643-651 CONGRESS STREET
(1922-1949) # 1

A. P. -- 645 Congress Street

Subject: Permit to cover enclosing existing
elevator shaftway of Columbia Hotel at
645 Congress Street

SECTION SHAFT LOOKING WEST

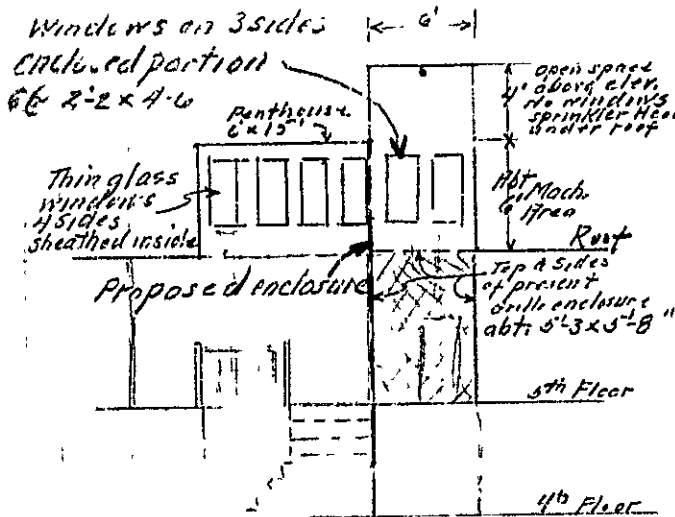
Penthouse windows are thin glass.

Approx area shaft top $5.25 \times 5.75 = 30.125$ O.K.

Window area $2.25 \times 4.5 \times 6 = 60.75$ Code allows for these small windows but question is applying here where we have a pocket of 144 cu. ft. to build up heat before the thin glass becomes effective.

9:20-49 Mr. Williams to provide filling metal interlocking doors. James Russell Carter Mfrs. Will apply for permit. No other work.
